January 28, 1985

SUBJECT: Limerick Generating Station, Units 1 and 2, Organizational Changes
in the PECO Electric Production Department

Attached are draft changes to FSAR Section 17.2, Figures 17.2-2, 3, 4, 5, & 15 and related 260 Series questions which describe the subject changes. These changes have been reviewed and it has been determined that the changes do not reduce the commitments in the QA Program previously approved by the NRC.

FIGURE 17.2-3 REV. 17, 02/83

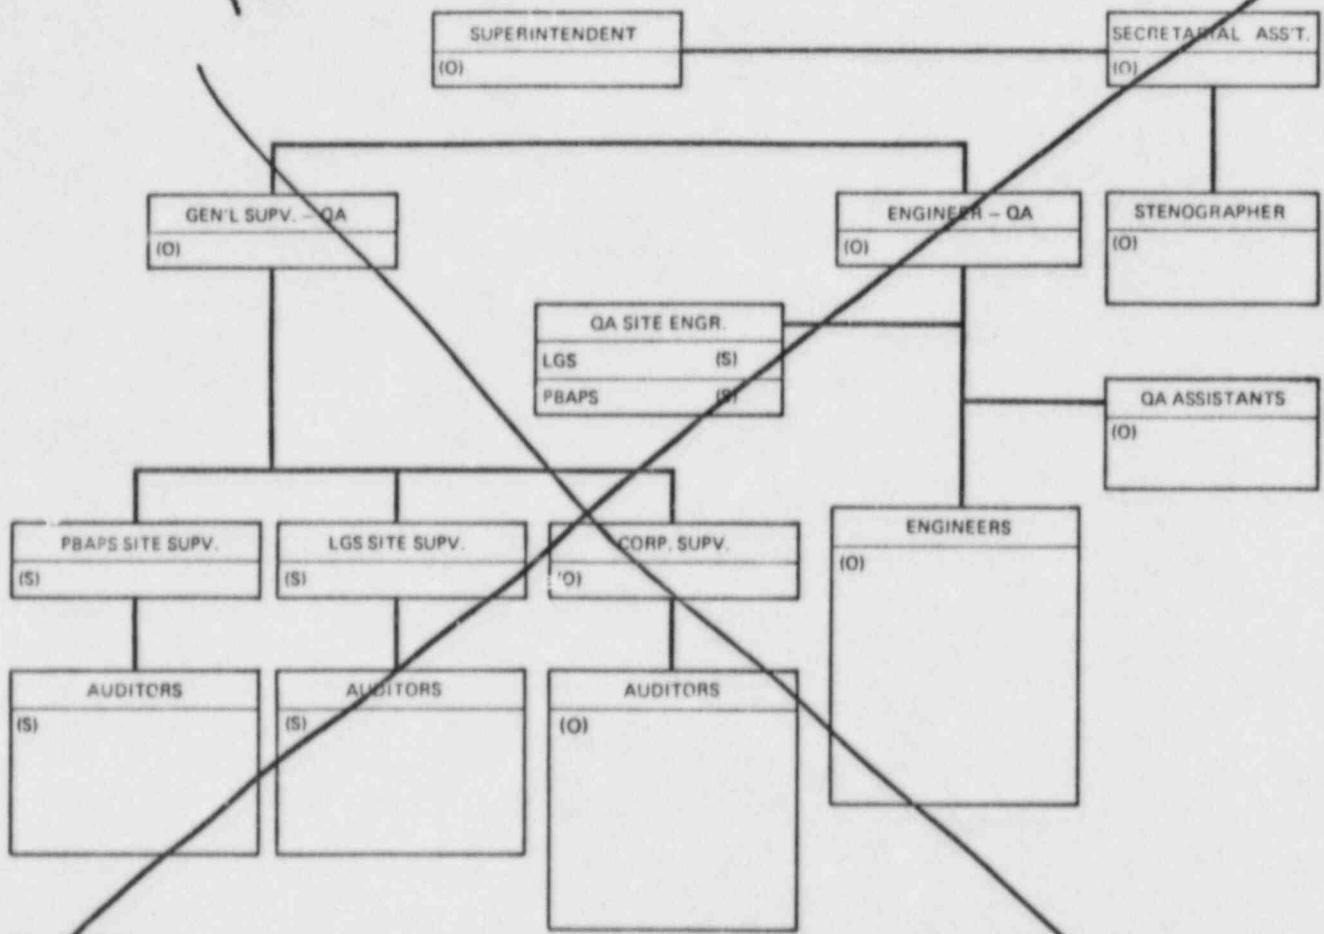
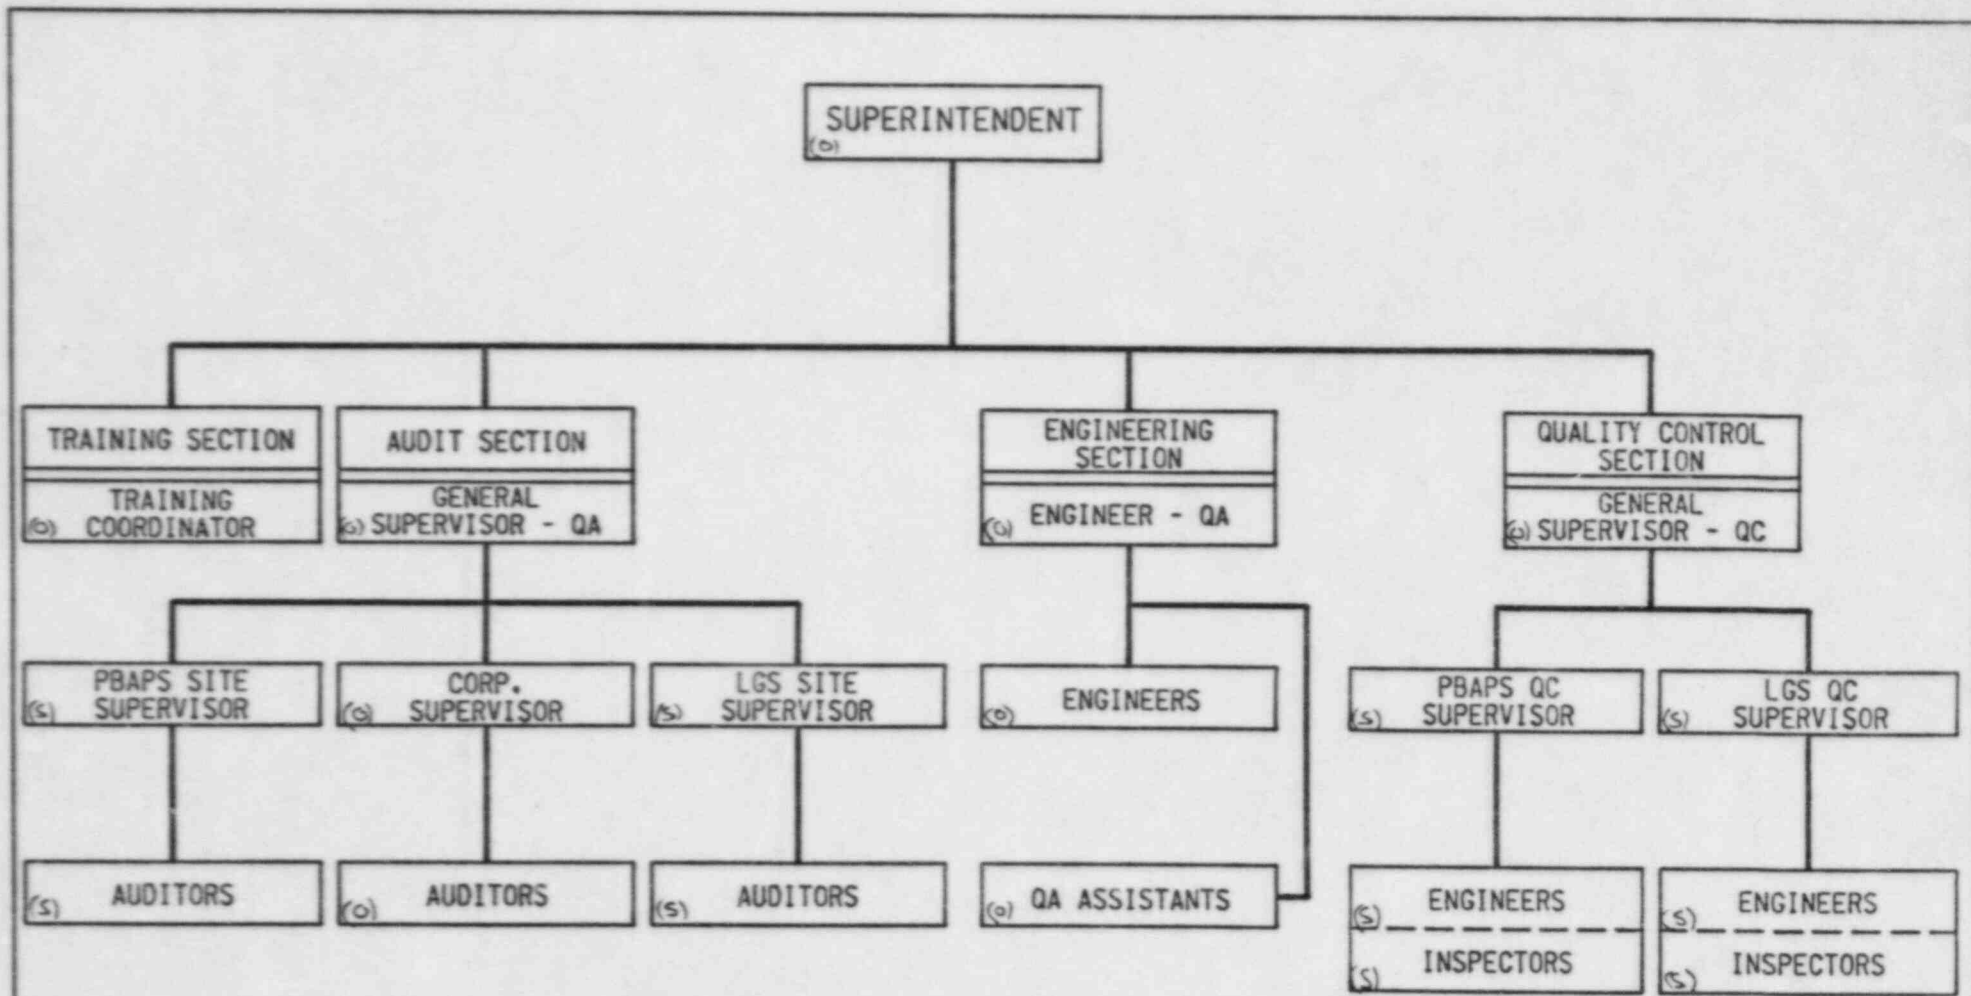
A

insert (B)

FIGURE 17.2.4

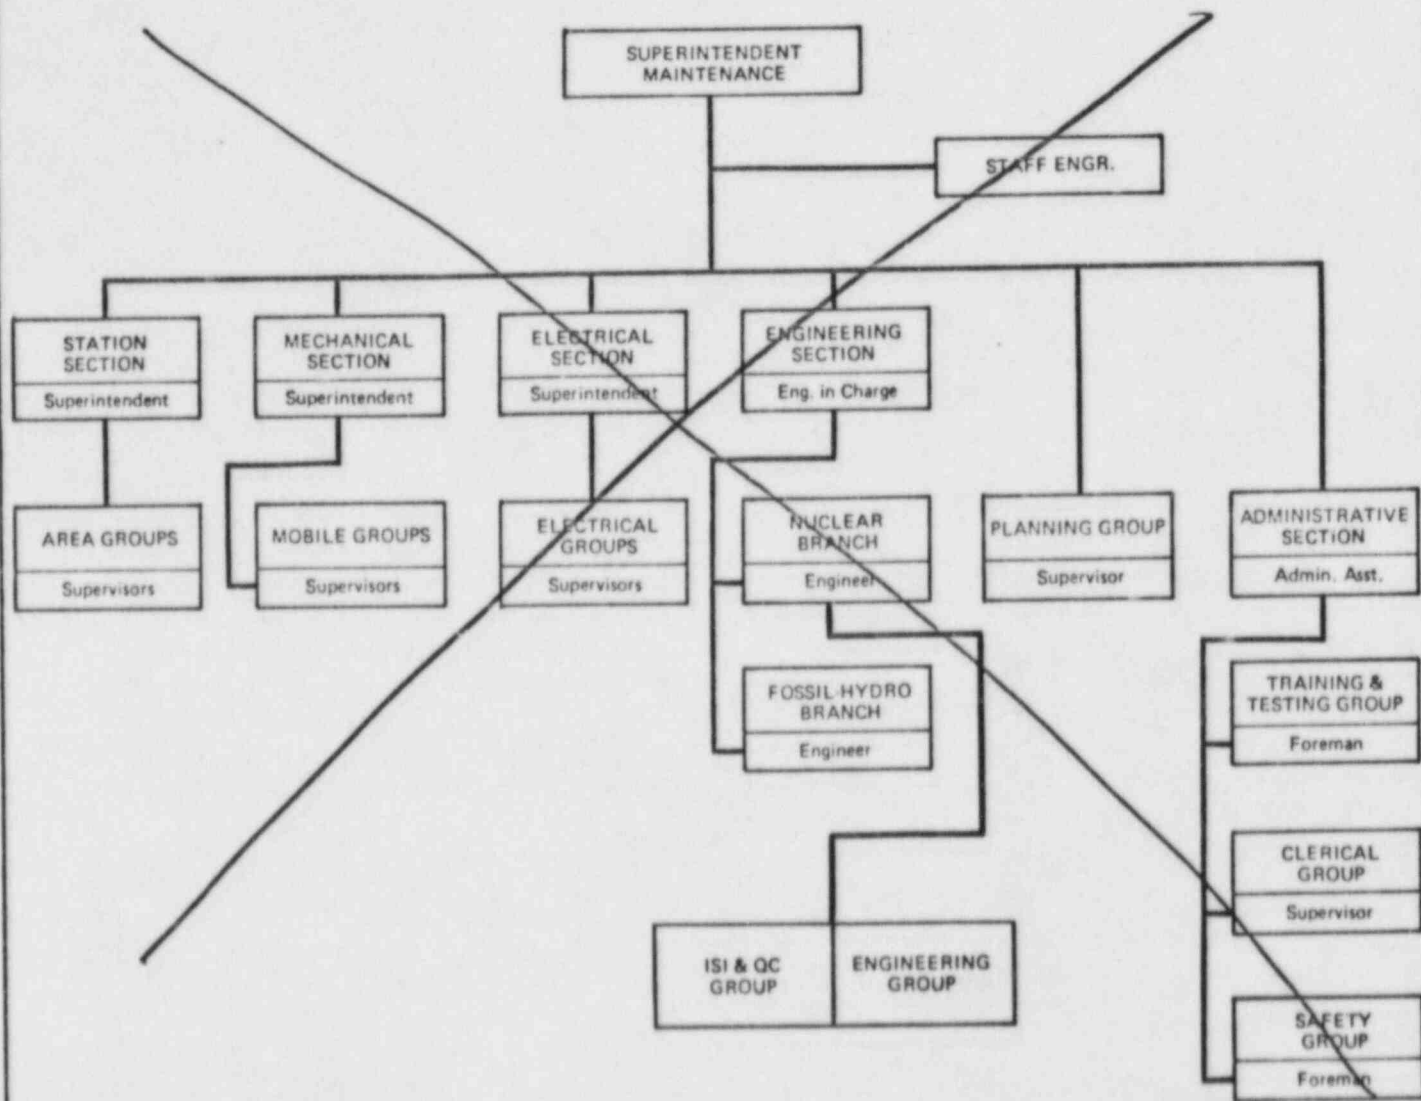
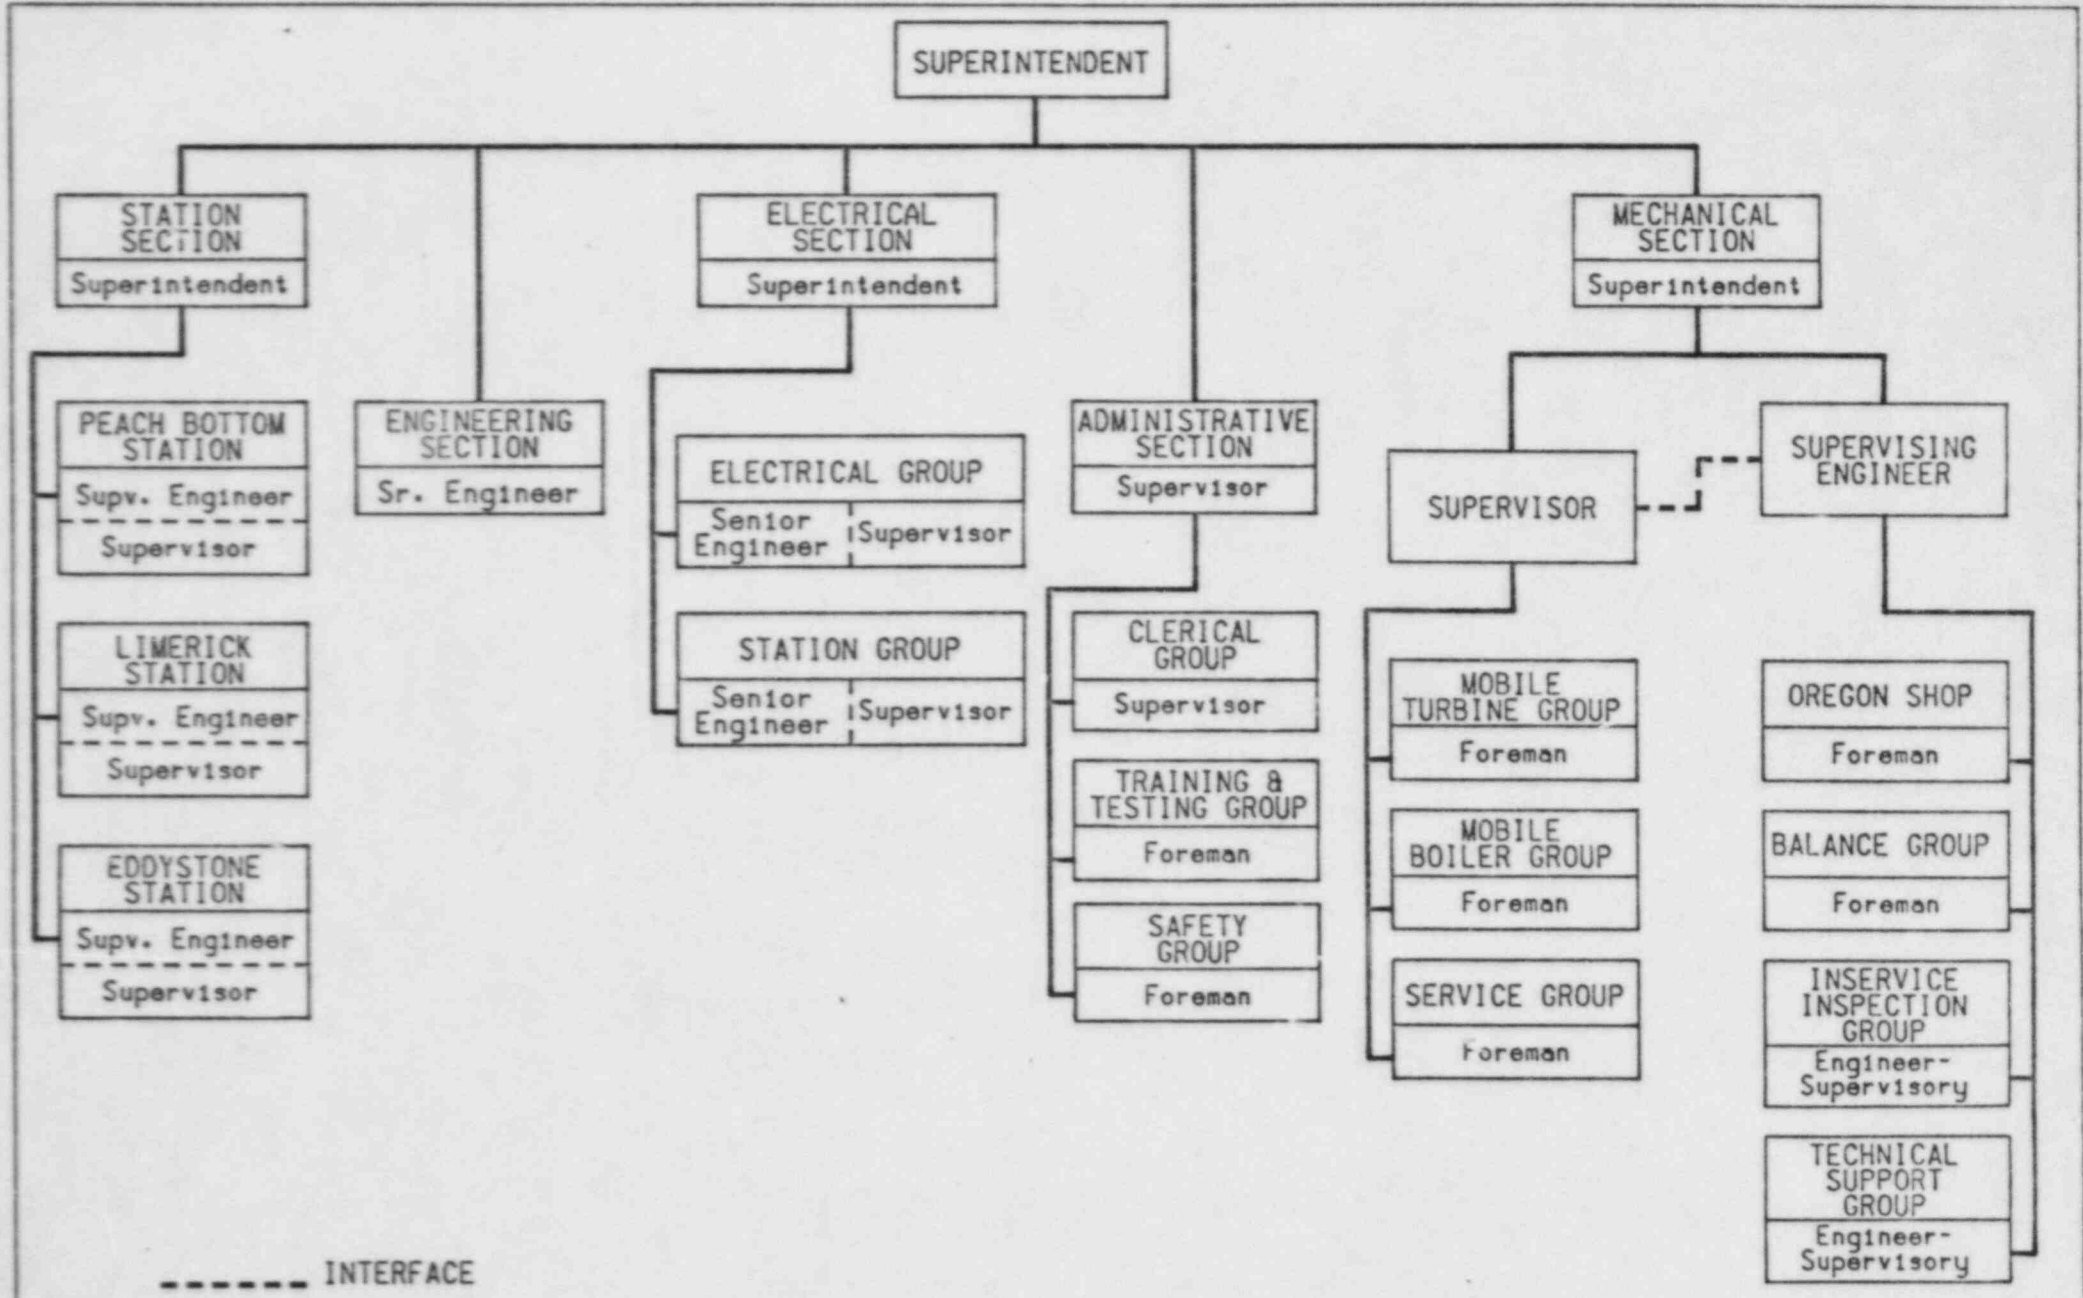
insert (c)

FIGURE 17.2-5 REV. 21, 06/83

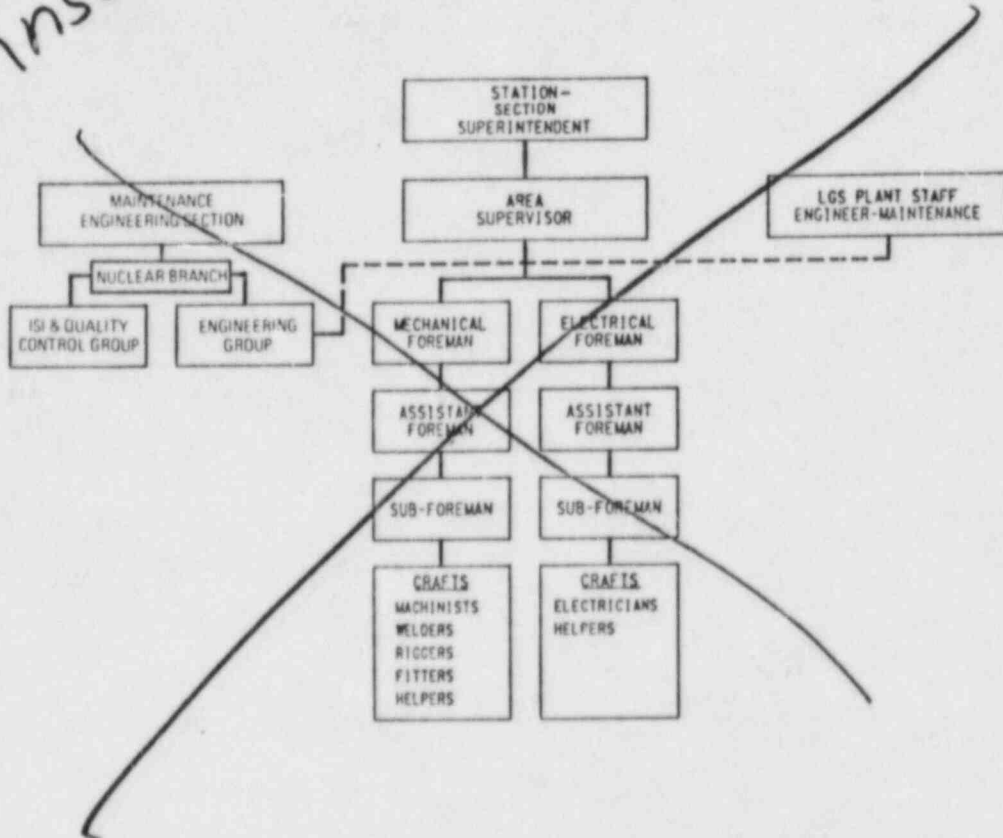
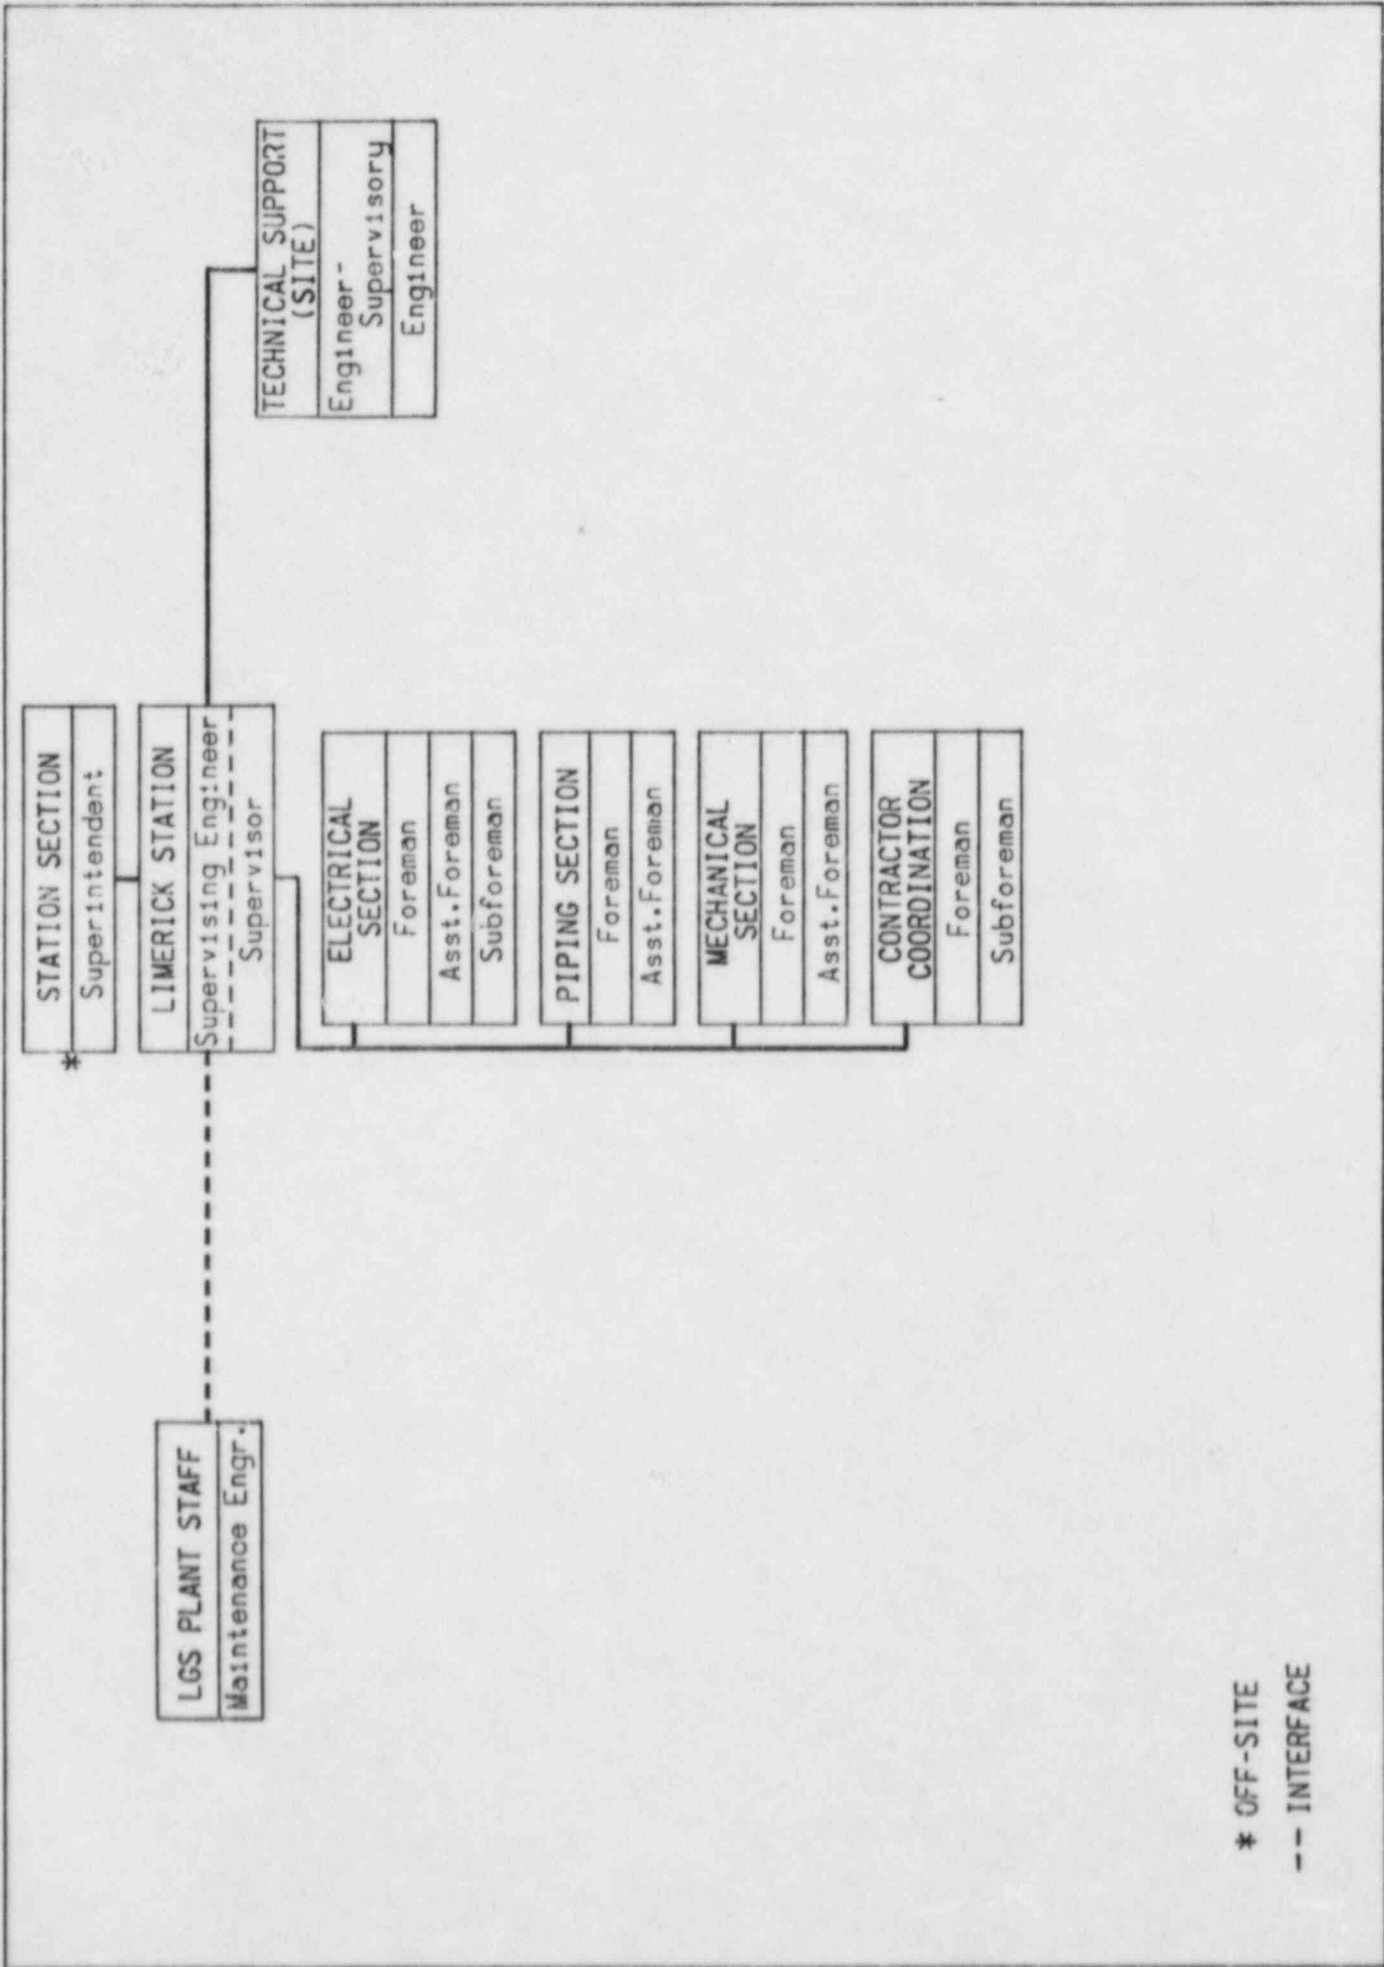
Insert (D)
